City of Oakley

ADDENDUM NO. 1 to contract documents for
OAKLEY RECREATION CENTER INTERSECTION IMPROVEMENT
AND SIGNALIZATION PROJECT, CIP # 194

BID OPENING DATE: May 18, 2017 2:00 PM

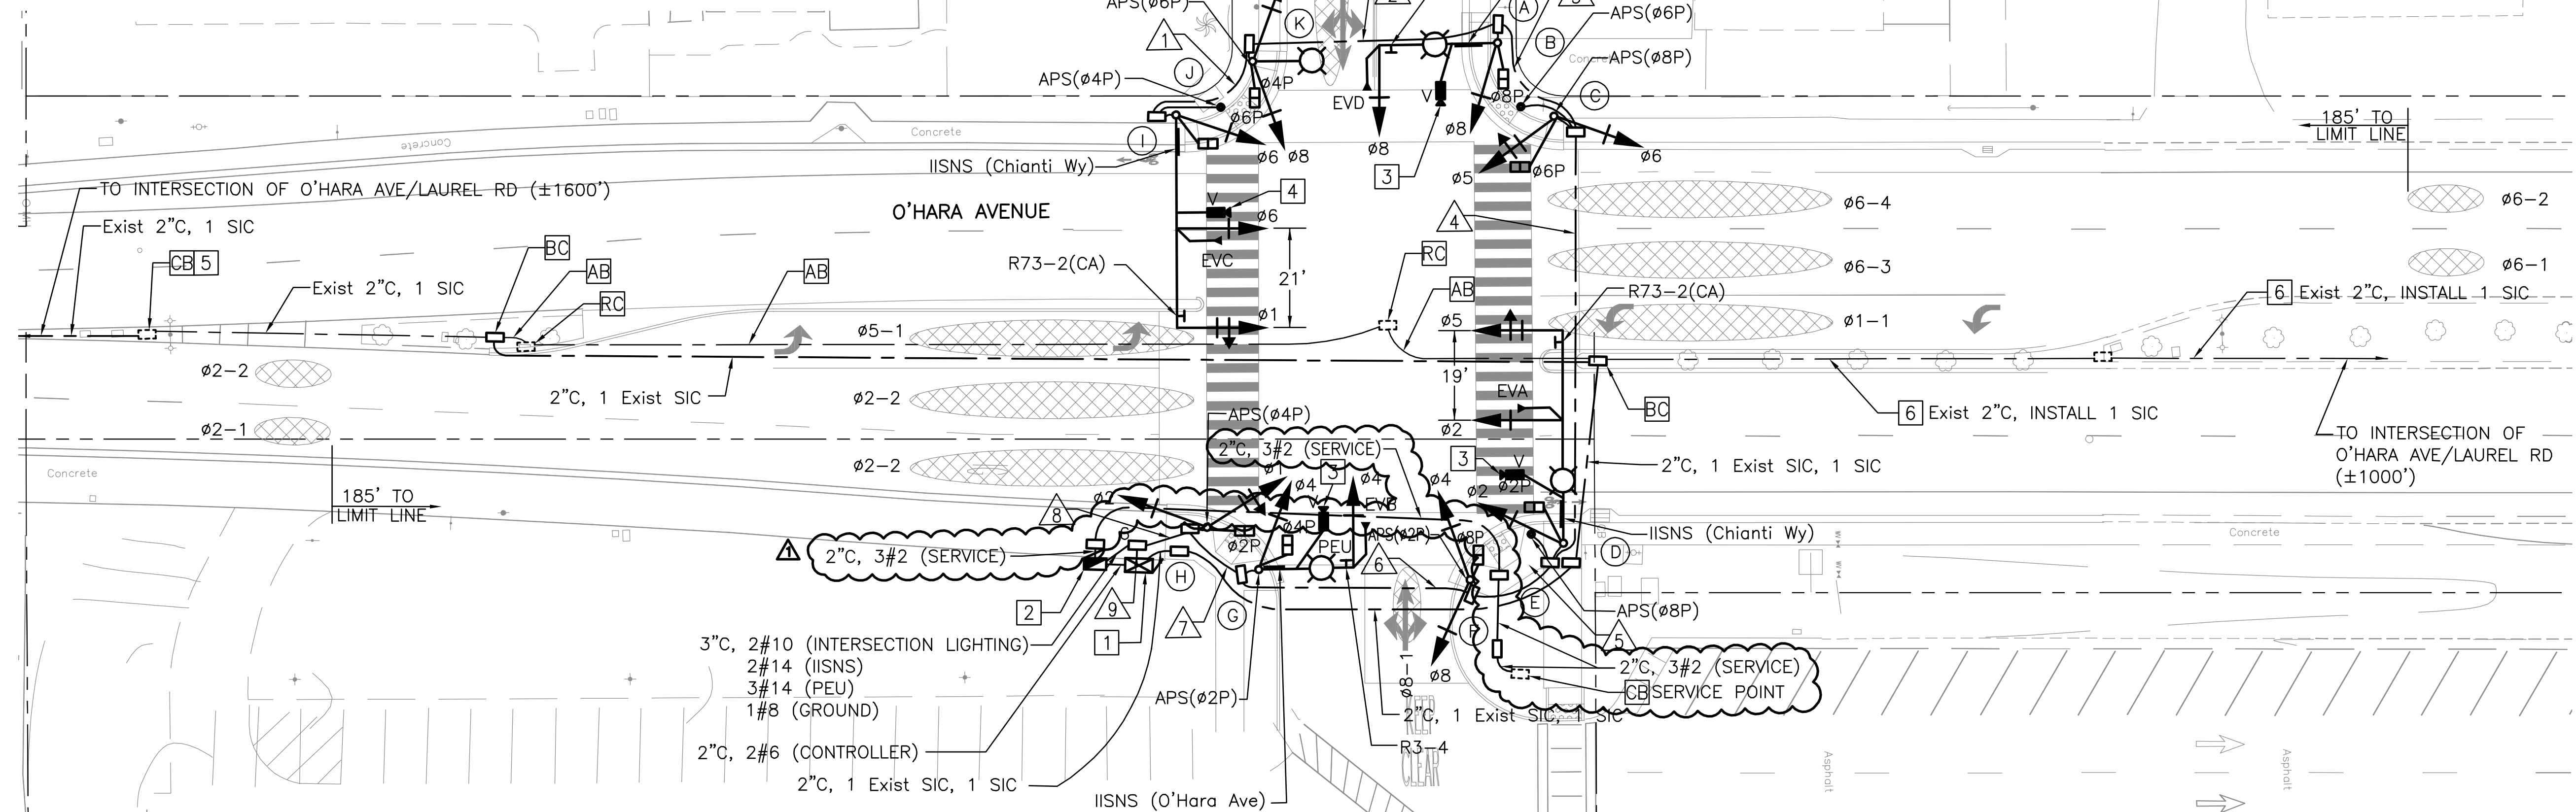
- Plan sheet E-1
